Report to the DCA

DEVELOPMENT CONSENT AUTHORITY
LITCHFIELD DIVISION

PROPOSED CONCURRENT APPLICATION PA2026/0080

Amendment proposal to rezone Section 05111 Hundred of Strangways (79 Fred's Pass Road Humpty Doo)
from Zone RL (Rural Living) to Zone LMR (Low-Medium Density Residential)

SITE COVER	=	10,000m2
SITE AREA	=	24,440m2
sITE COVER	=	41%

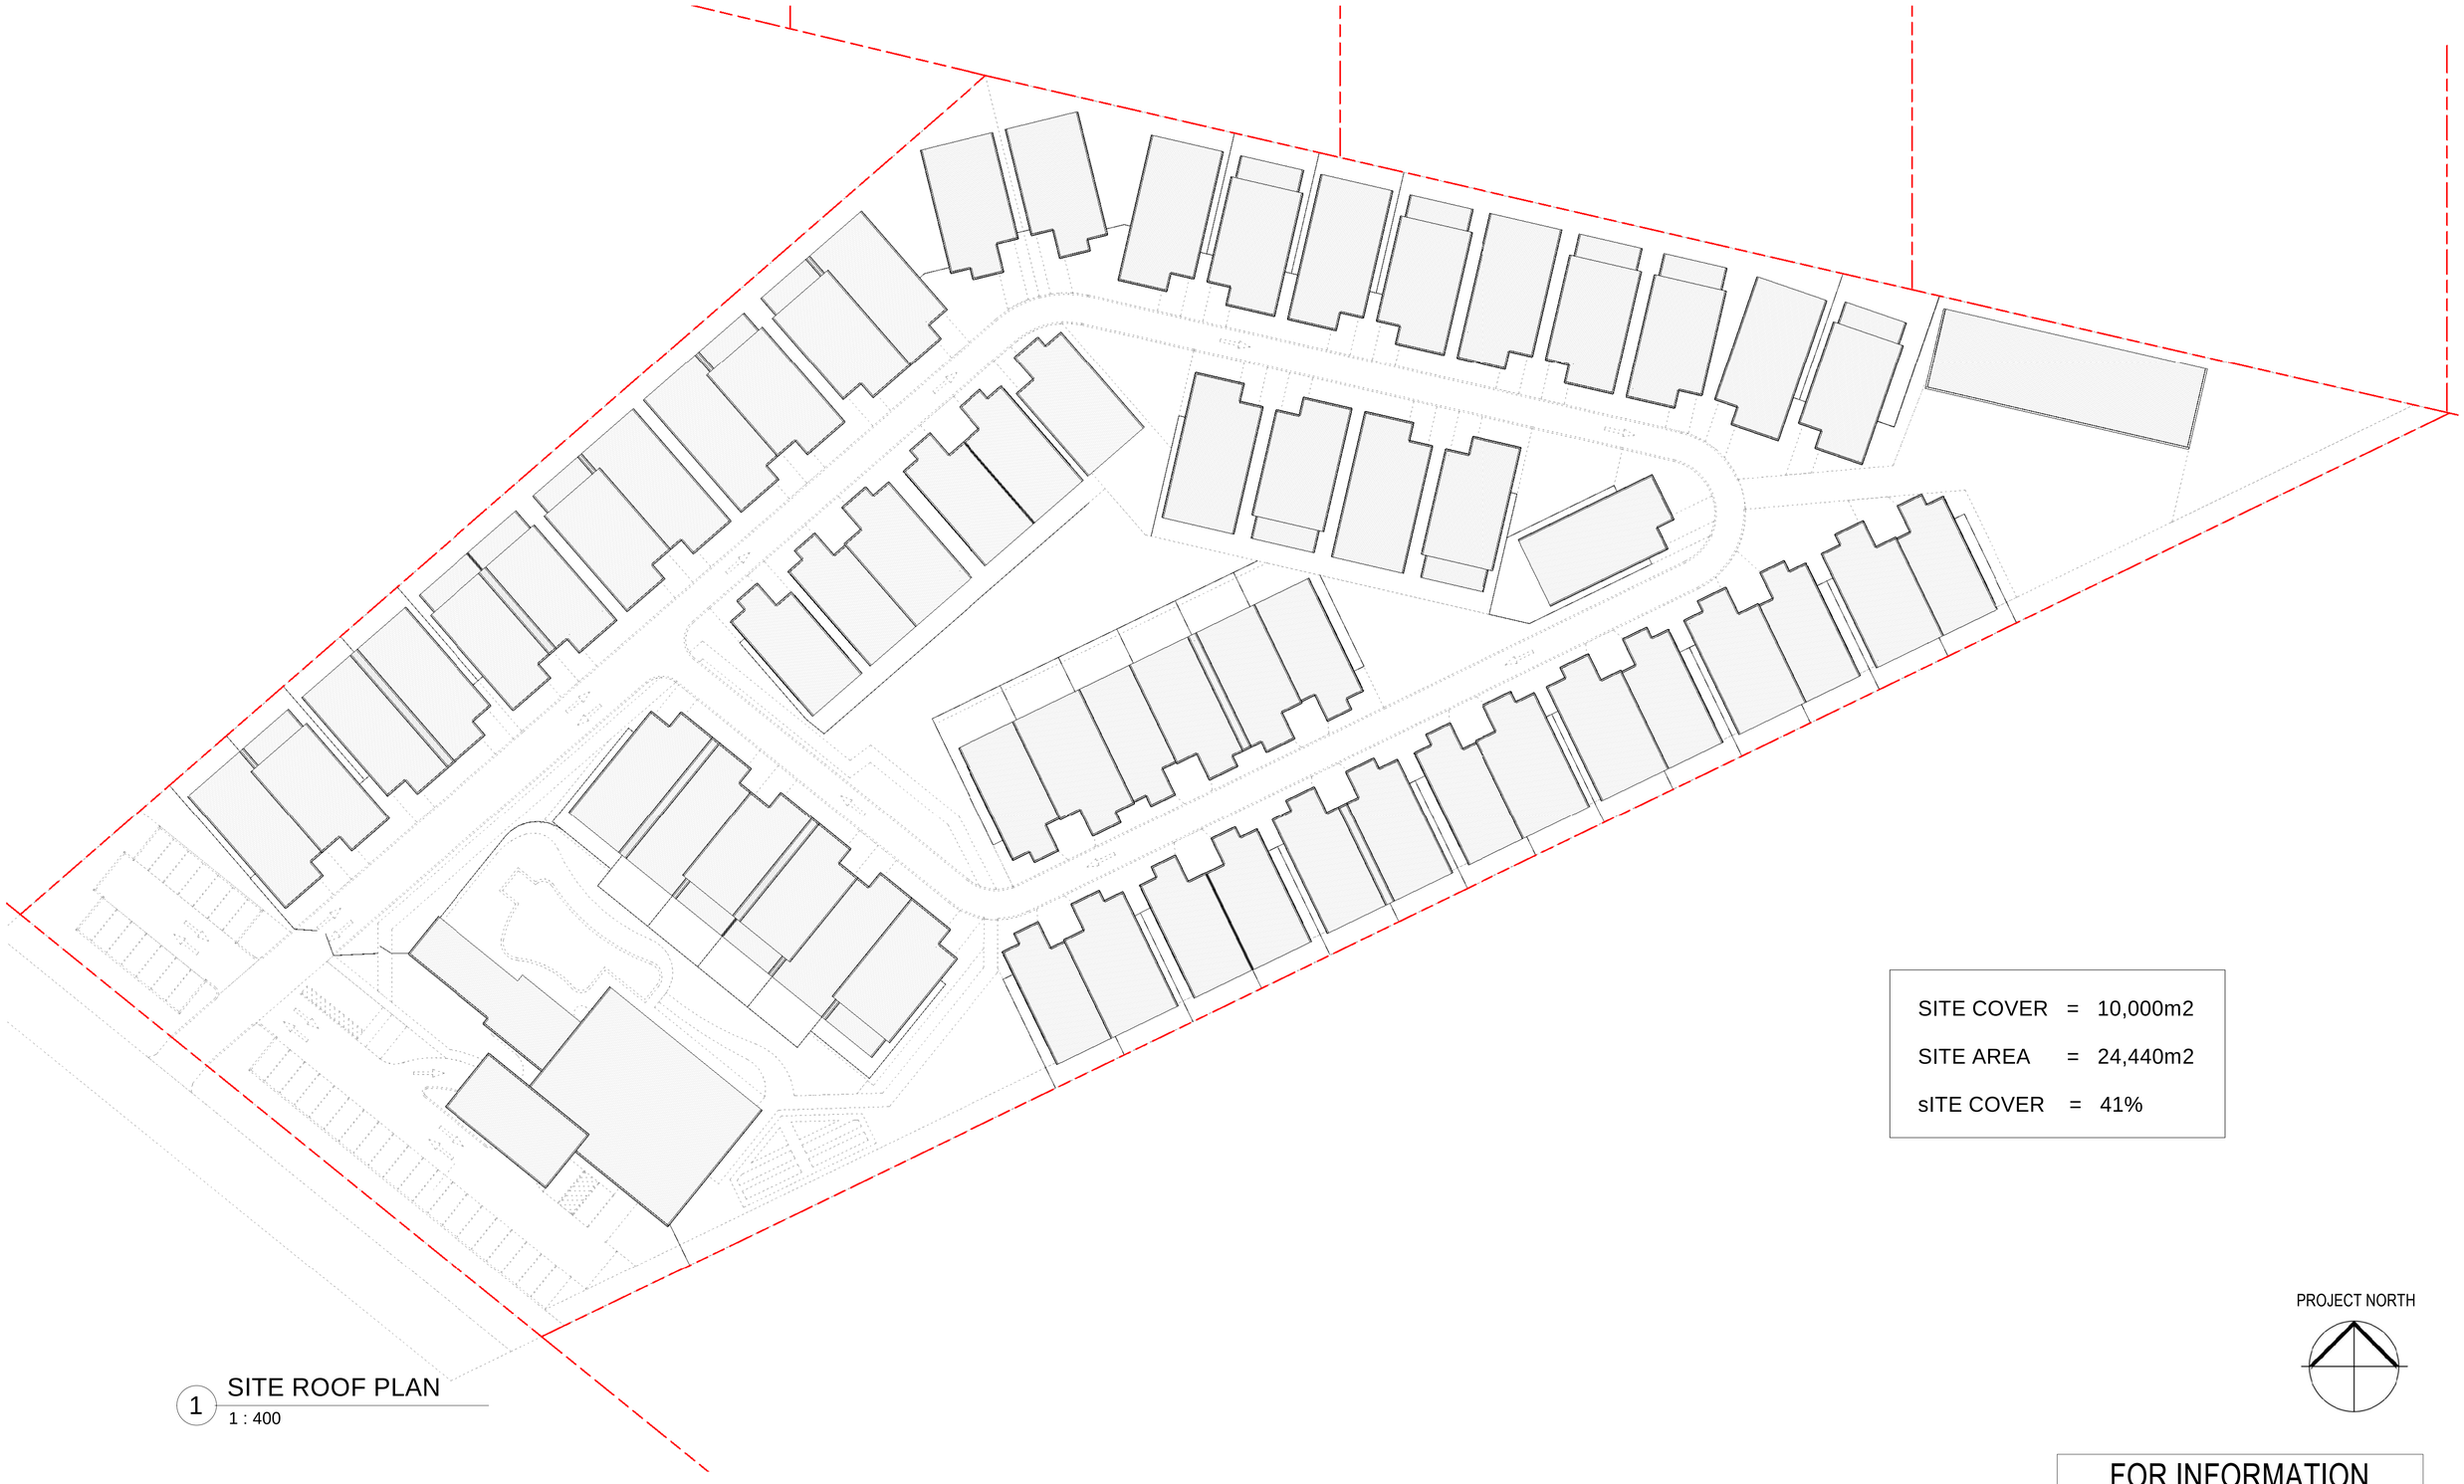
- The residential development setbacks from the neighbouring sites on either side and to the rear are minimal. The POS provided is minimal. The density proposed is greater than that indicated in the LMR and the proposal is not a graduated density response, but the proposed high density residential area with minimal boundary setbacks, located around the edges of the site and this would not protect rural amenity.

- Deletion of 6 x Type02c Dwelling units adjacent to Road 03 (as shown on the Site Plan submitted with the application). This is to facilitate Crime Prevention Through Environmental Design Principles by increasing surveillance opportunities to the area shown as "Park" on the Site Plan.

The proposed Community Centre shows a landscaped response however the group dwellings and the Park/ Open Space do not have a landscaping response.

The dwelling-group does not have private open space. There are minimal dimensions of rear open space located behind each unit but these are not separated by internal fencing or planting to create privacy and are not intended to be private open space.

These design issues could be resolved through precedent conditions that require amended plans with a reduction in dwellings consistent with the zone, internal and external access arrangements supported by a Traffic Impact Assessment (TIA) with pedestrian & cycling paths both internally and to surrounding areas, landscaping, CPTED responsive open space and greater housing choice.

Landscaping requirements could be addressed through a precedent condition for amended plans which would require a Landscaping Plan which requires the whole site – Community Centre and Group Dwellings to have:

This could be addressed through a precedent condition for amended plans which would require private open space to be provided to each unit which addresses the requirements of the clause:

Figure 4: *Building lengths exceeding 15m*

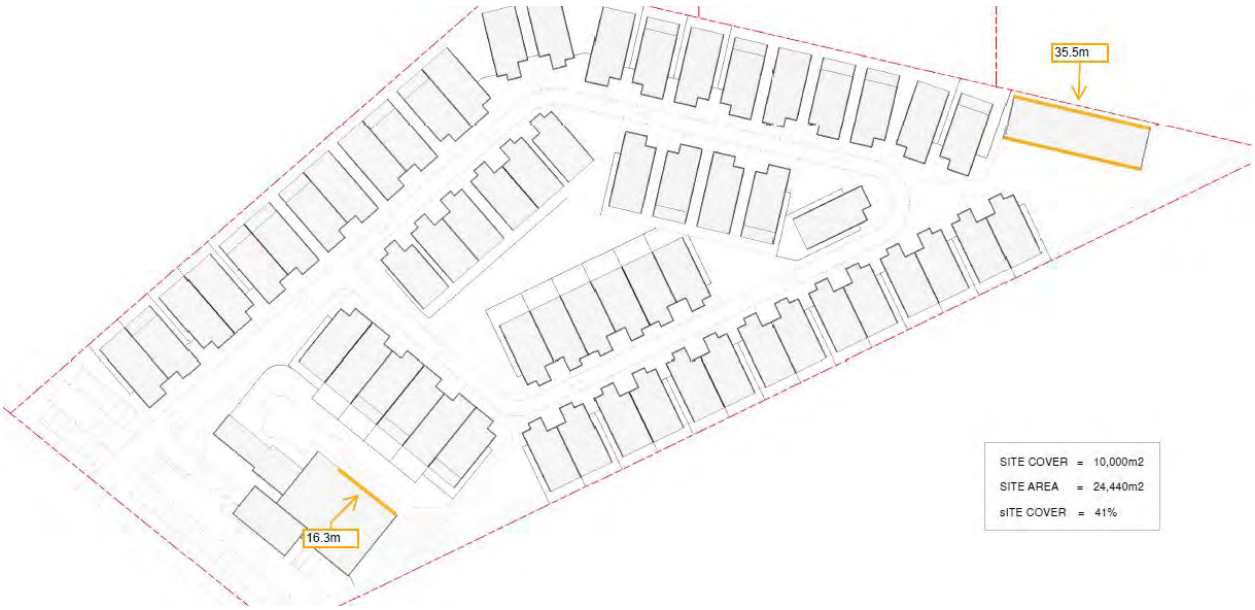
Building lengths exceeding 15m, where they are not associated with a verandah (per subclause 3) are identified in **Figure 4** below. They relate to:

- the proposed residential storage sheds; and
- part of the proposed community/reception building

Administration subclause 2 allows the consent authority to vary the requirements of this clause if it is satisfied it is consistent with the purpose of this clause. In response, the following is noted:
